#### **ADDENDUM #3**

PROJECT: CODESTACK ACADEMY

REF. # : ARCH PROJ. No. 2023-04

DATE: 27 November 2024

A9.2.11

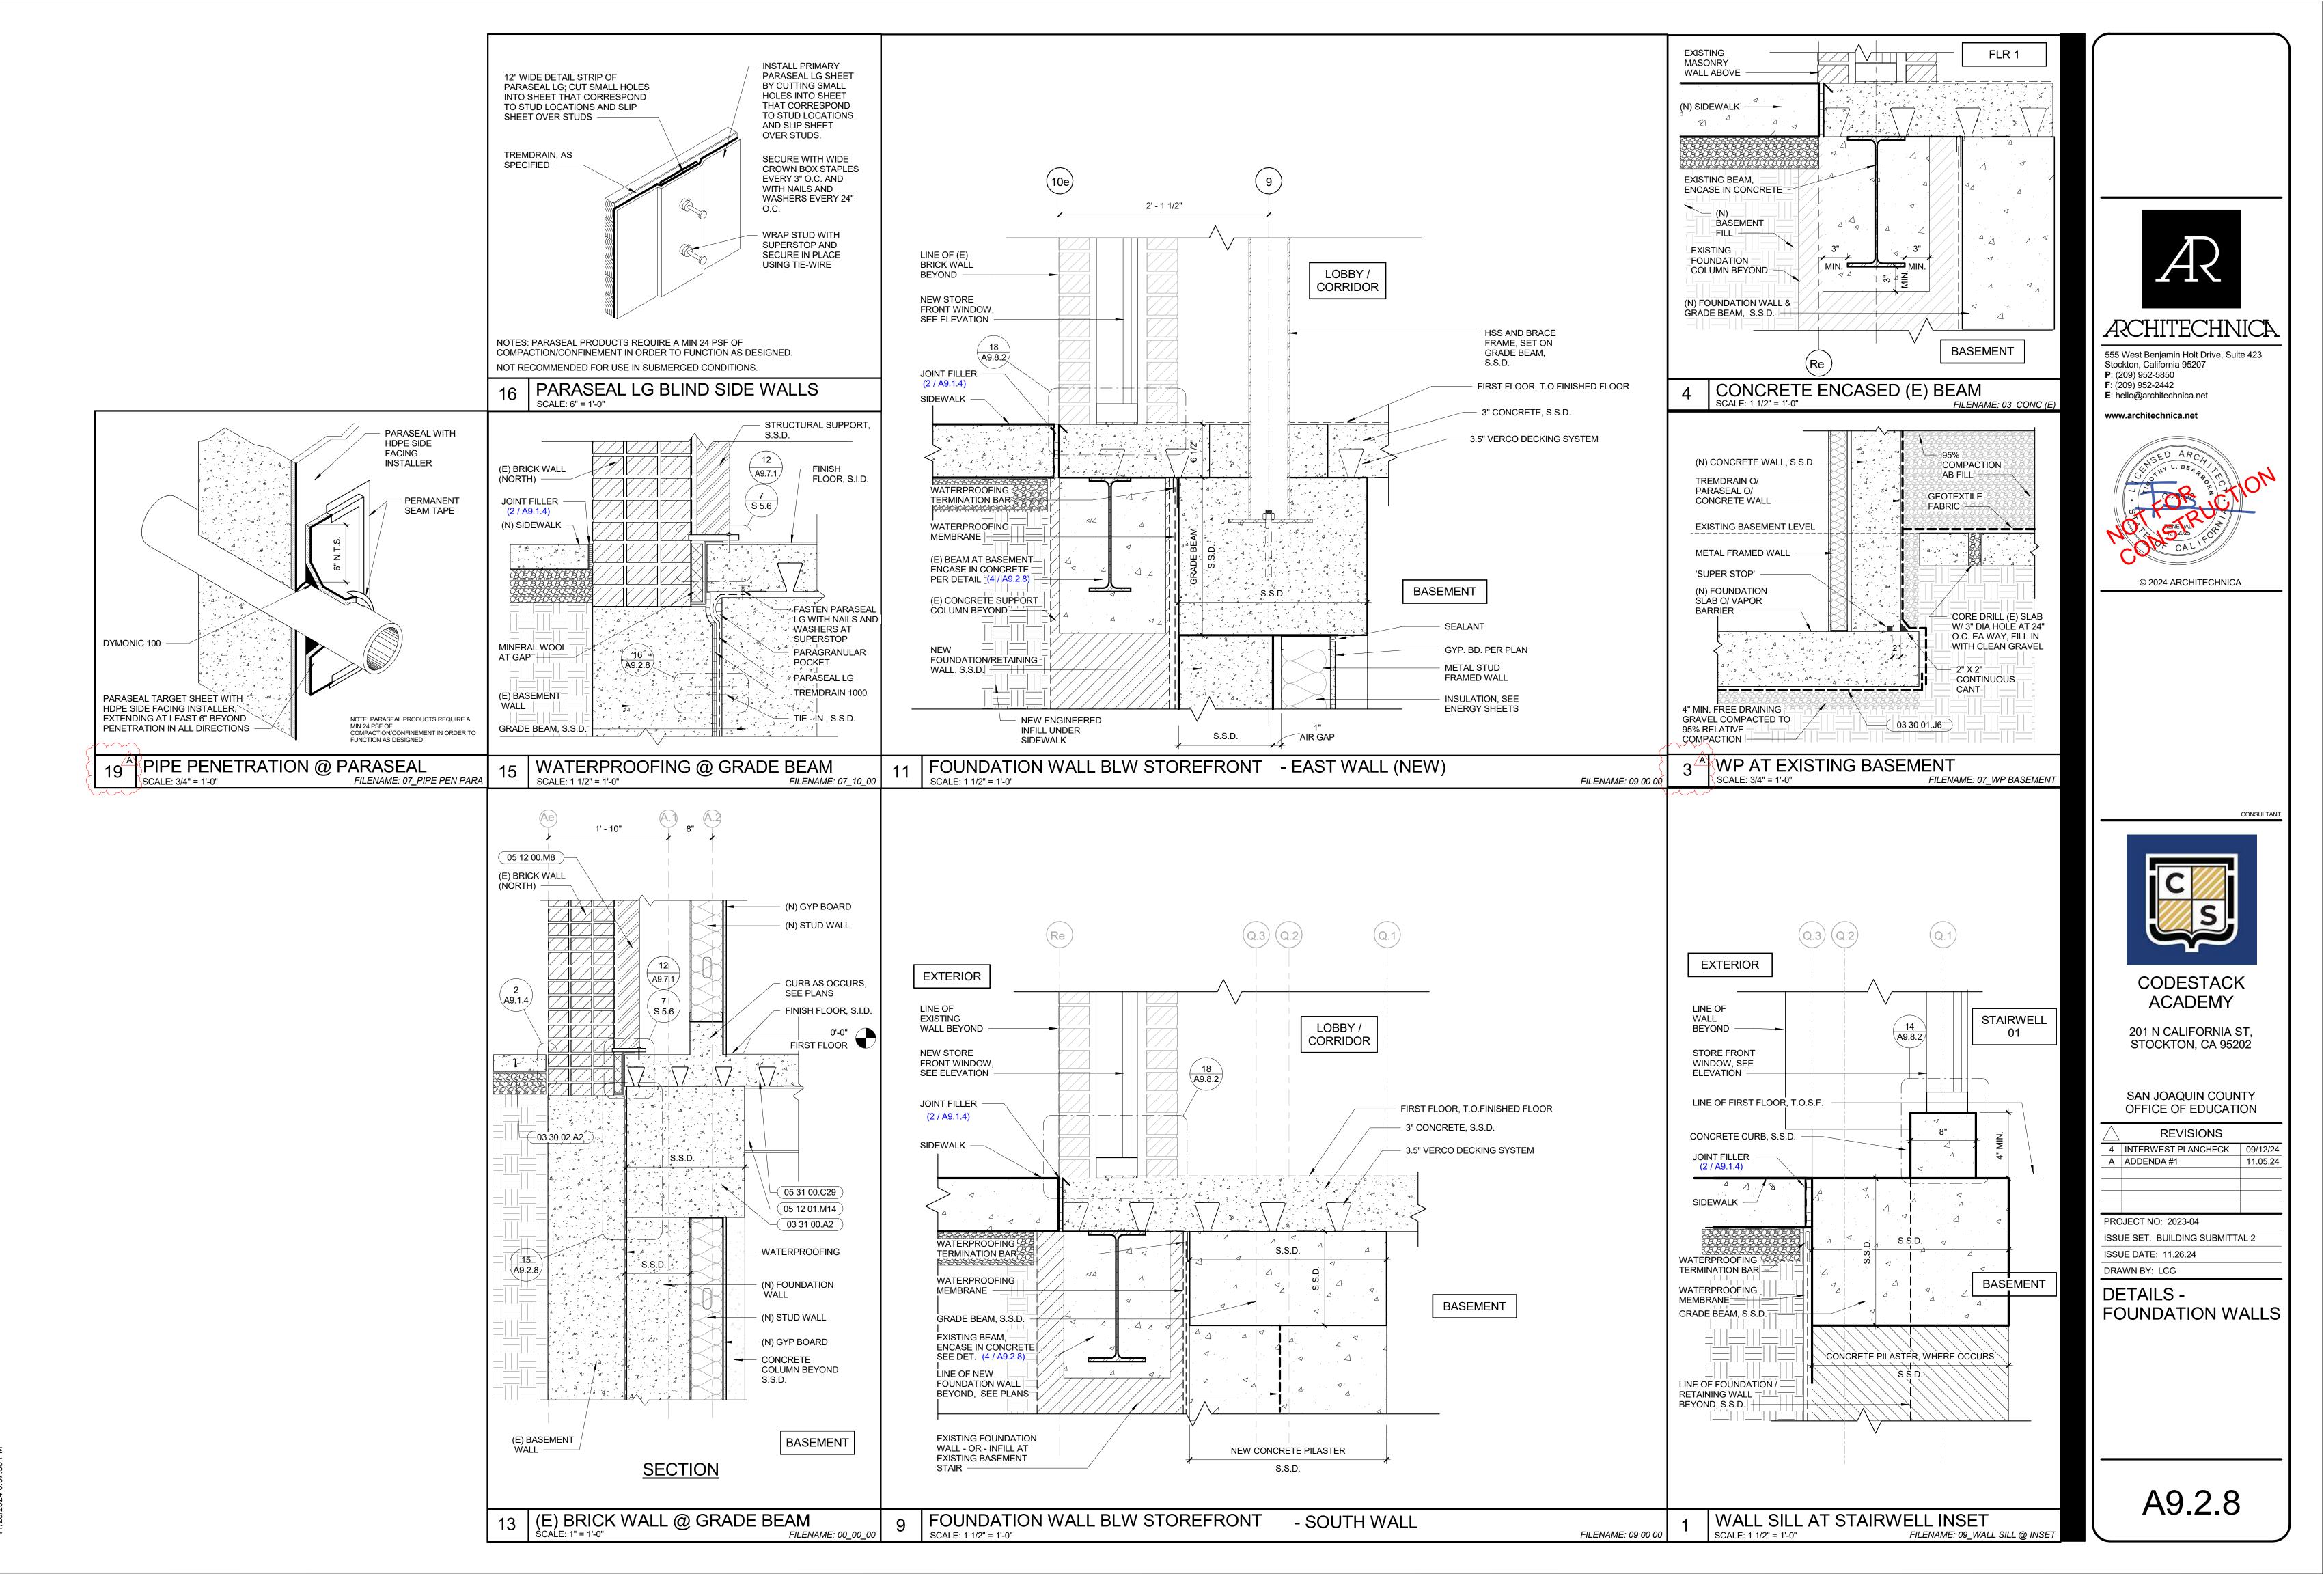
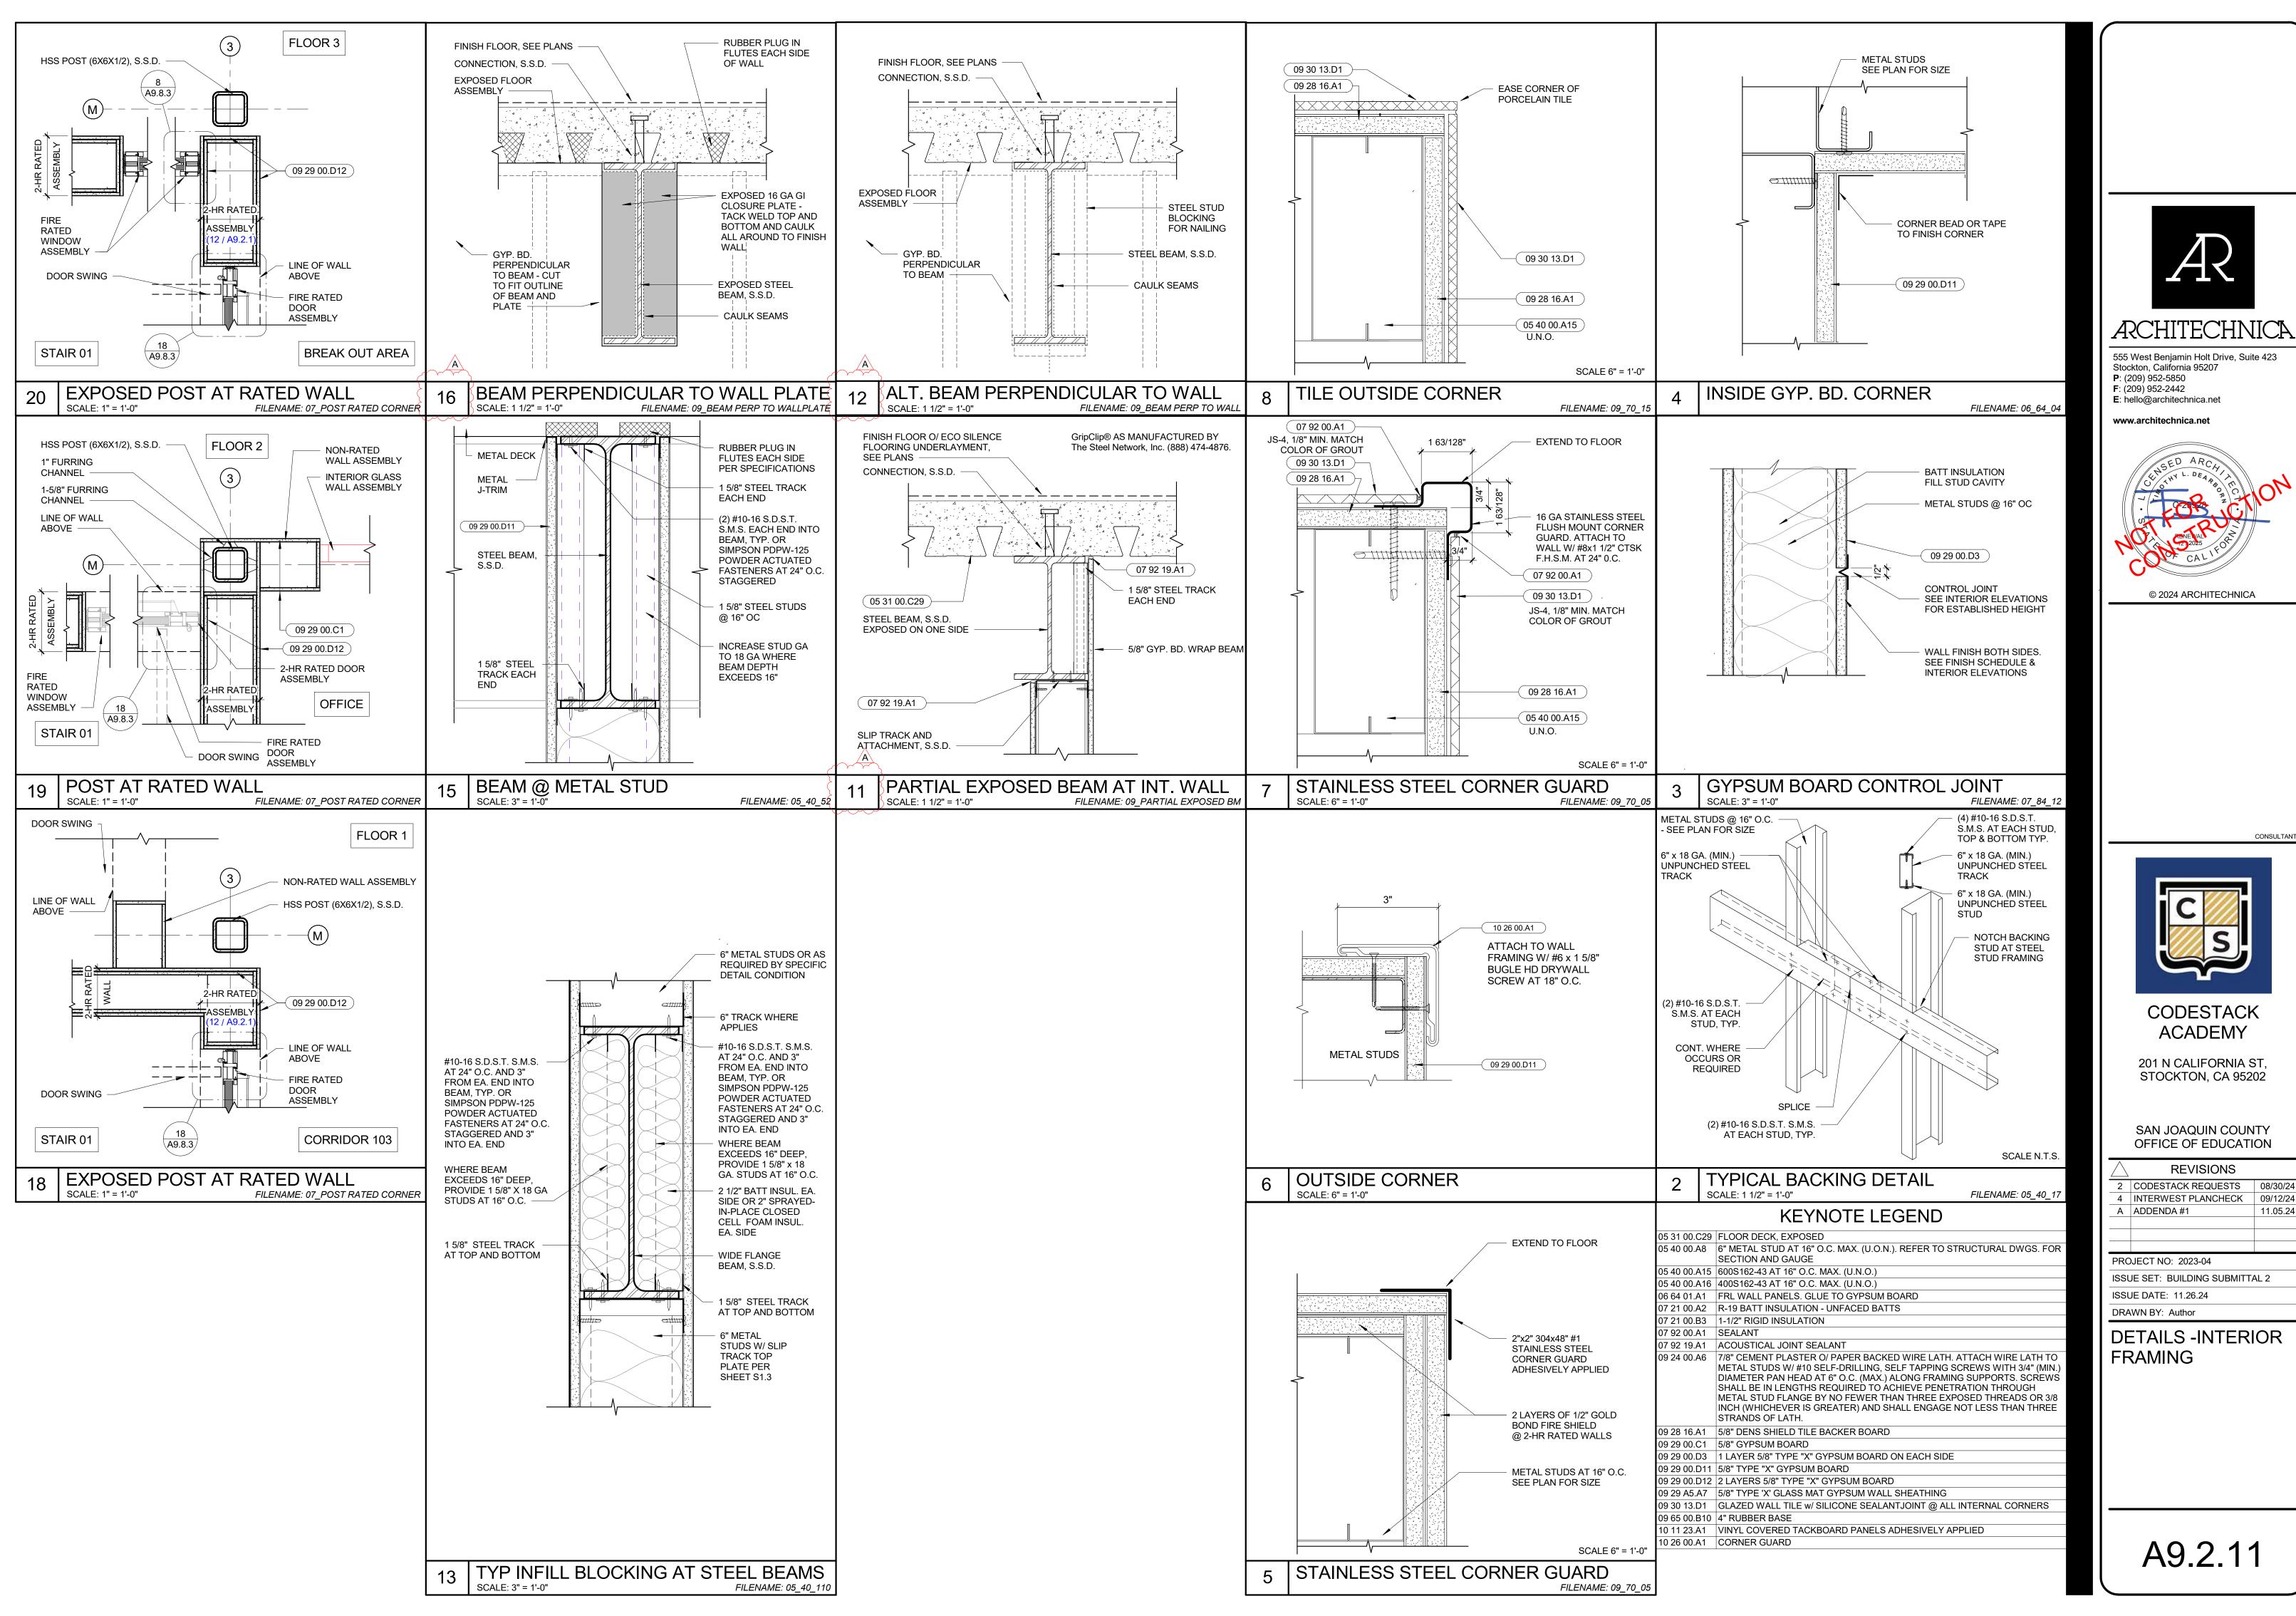
#### ITEM 4 A9.2.11

Added detailing for beam to wall. Detail 16.
